Project: Mankato to Mississippi River Project  
23-157

**Supplemental Information Inquiry 2**

Project: Mankato to Mississippi River Project  
23-157

Figure 1

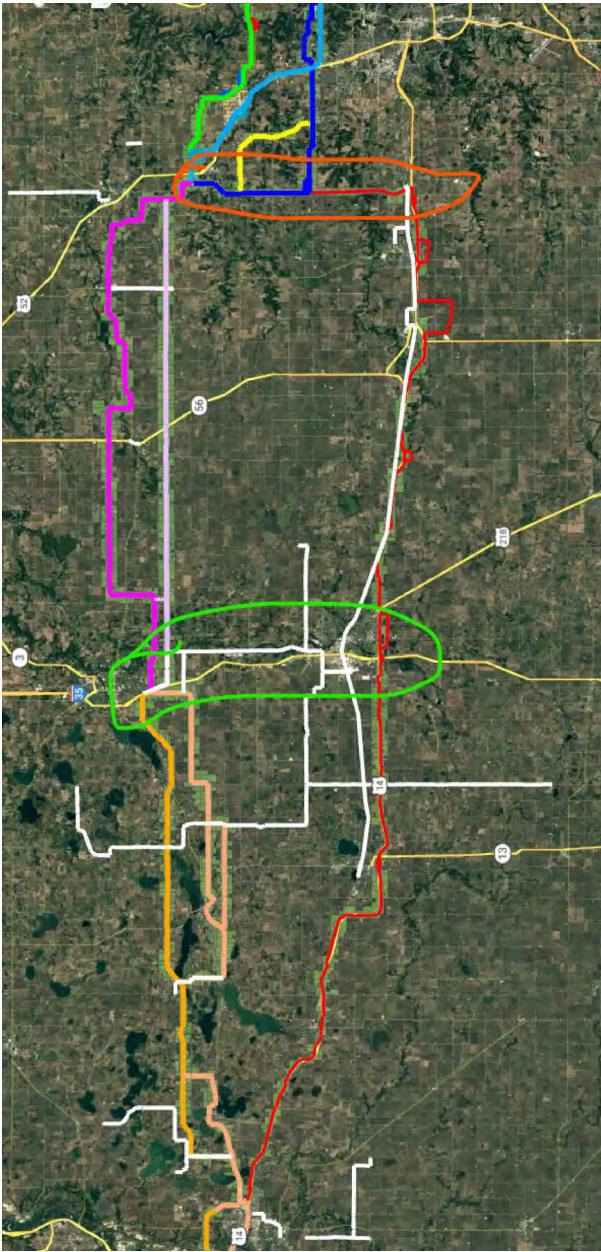
4. This request pertains to Route Segment 17 (Hwy 14 option). Xcel's August 28, 2024 letter responding to scoping comments noted the potential future need to connect to the West Faribault Substation. This was also noted in Xcel's route permit application (Section 2.7 Design Options to Accommodate Future Expansion). The potential connection of the project's 345 kV transmission line to the substation would serve the future purpose of connecting the lower voltage transmission system to the backbone (345 kV) transmission system. Your email dated 10/18/2024 to EERA reiterated: "The proposed alignments in our application did not connect at the West Faribault Substation, but routed close to it, based on the expectation that in the next several years it will be necessary to connect that sub to the 345 kV system. We are doing some more research to try to clarify when that would be needed, and what the alternative would be if the 345 isn't close (possible other system upgrades, etc.) but wanted to note that a Hwy 14 alignment may necessitate a future, additional 15ish mile 345 kV line (green circle in the screenshot below for approximate location) to connect to West Faribault." The screenshot provided by Xcel is shown below as Figure 1. Please provide an estimated construction timeline that Xcel would anticipate that the connection to the West Faribault Substation could be required and any updates on the potential for the 15-mile new transmission line and its necessity.

A construction schedule is not available at this time as the exact timing for when there will be a need to connect the 345 kV system to the West Faribault Substation is not known at this time. However, we expect there will be a need to connect the 345 kV system to the West Faribault Substation in 10-15 years. The exact timing of the need for this connection will depend on potential generation retirements and the development of new renewable generation in this area.

MISO Long Range Transmission Planning Tranche 2.1

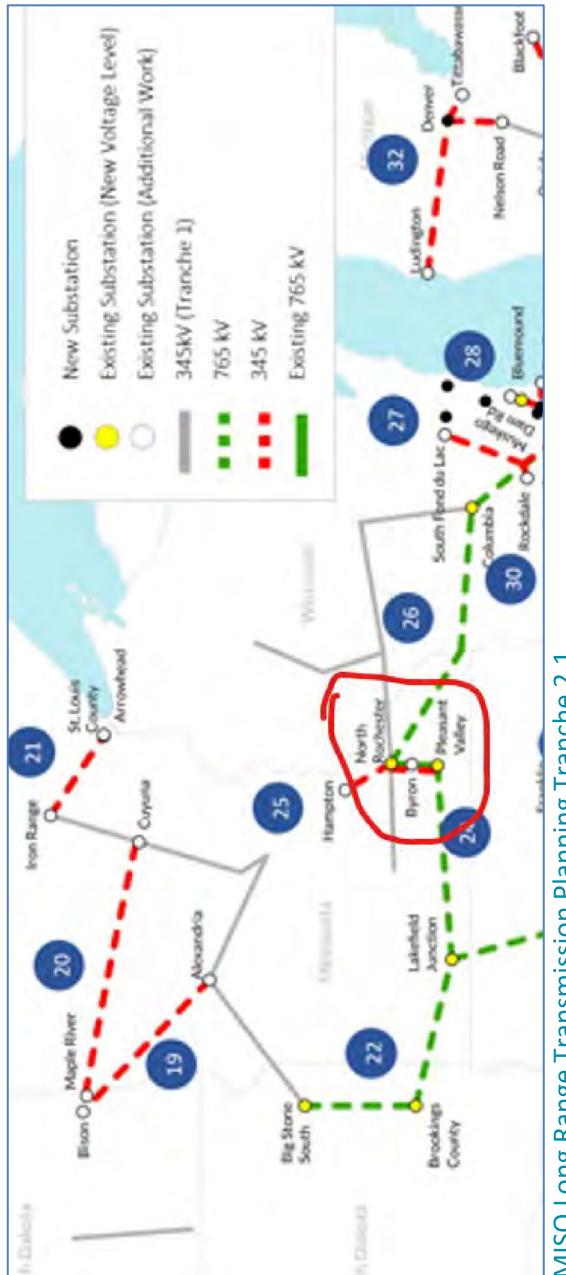
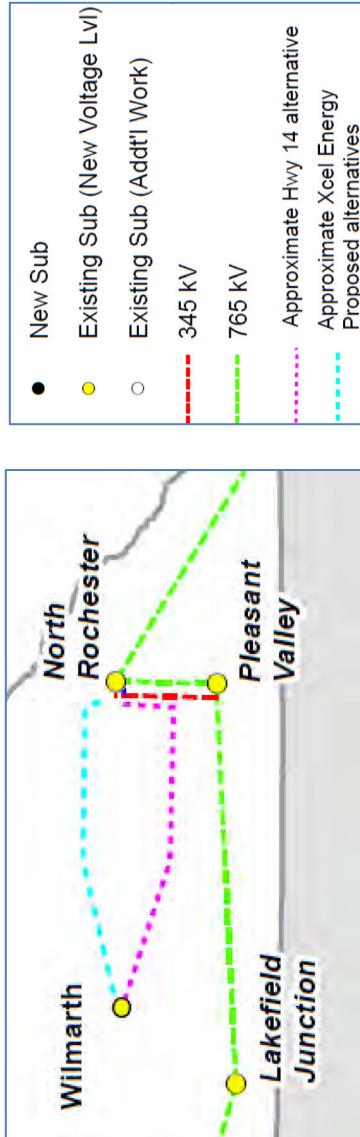
5. This request pertains to Route Segment 17 (Hwy 14 option). Xcel's August 28, 2024 letter responding to scoping comments states: "In addition, the Highway 14 would also require a new approximately 13-mile long 345 kV connection from the Byron Substation to the North Rochester Substation. There is already a 345 kV transmission line between these two substations such that this new 345 kV line could be double-circuited with the existing line. However, this area of the system is expected to require an additional 345 kV connection from the Byron Substation to the North Rochester Substation in the future and double-circuiting with this existing 345 kV line at this time would make this future 345 kV connection more difficult." Your email dated 10/18/2024 to EERA reiterated this point and circled the area in question in orange in Figure 1 above. For inclusion in the EIS, please provide addition detail of what would make the future 345 kV connection "more difficult." Please also provide an estimated construction timeline that Xcel would anticipate that the additional 345 kV line could be required.

The MISO Tranche 2.1 portfolio is expected to be approved in December 2024. That portfolio includes a new 345 kV transmission line from Pleasant Valley to North Rochester with an in-service date of 2032 (as well as a new 765 kV line from Lakefield Junction to Pleasant Valley to North Rochester to Columbia (in Madison, WI)). See screenshot below and the link to MISO's web site.

The Pleasant Valley to North Rochester project follows an existing 345 kV transmission line (line #0979) and assumes rebuilding that line to a double-circuit 345/345 kV line. If the Highway 14 alignment is selected for the MMRT Project the Byron to North Rochester portion of that option would involve double-circuiting with the existing line 0979. This would mean that it is no longer possible to double-circuit that portion of the upcoming LRTP Tranche 2.1 Pleasant Valley to North Rochester line with the existing line, as that position will be taken. This will necessitate finding a new route for the LRTP 2 Tranche 2.1 345 kV line. We have attempted to illustrate with some edits to the MISO map as shown below (note this does not show existing lines such as the existing Pleasant Valley to North Rochester 345 kV line).

Figure 2

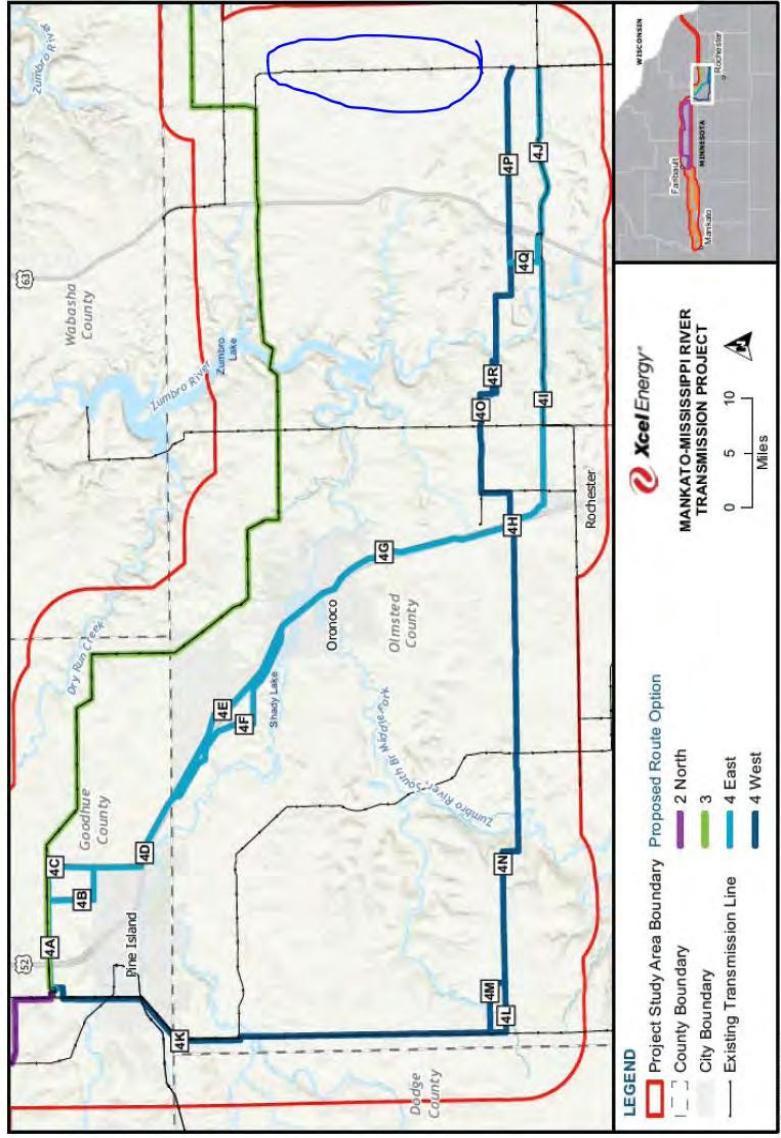
9. If Proposed Route Option 4 East or 4 West were selected, please confirm if the portion of the existing 161 kV line circled in blue Figure 2 would be removed or remain in place.

The status of this segment needs further investigation by the applicants to confirm future intent.
